UNITED STATES PATENT AND TRADEMARK OFFICE

APPLICATION NO.	FILING DATE	FIRST NAMED INVENTOR	ATTORNEY DOCKET NO.	CONFIRMATION NO.
10/812,449	03/29/2004	Pauline Maria Foster-Hamilton	0707-00342 - G00342/US	3169

Office Action Summary

DETAILED ACTION

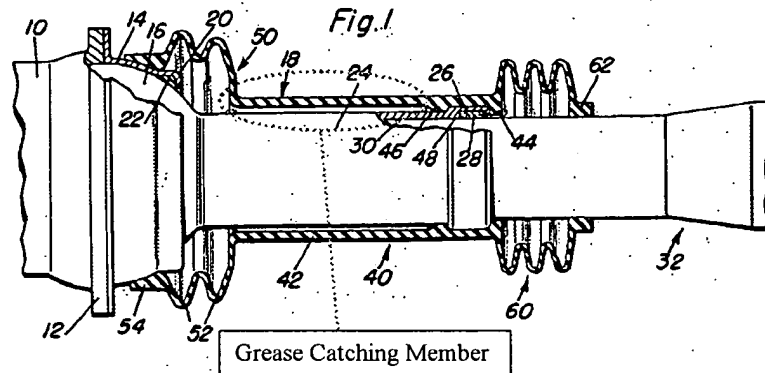
In regards to claim 1, Davis discloses an improved boot for use in sealing a constant velocity joint and ball spline joint assembly, the boot (40) comprising:

a plurality of articulating convolutes (50);

a grease catching member (46);

a first stabilizing member (see Figure 1 below) joining the plurality of articulating convolutes and the grease catching member;

a plurality of plunging convolutes (60); and

a second stabilizing member (44, 48) joining the plurality of plunging convolutes and the grease catching member.
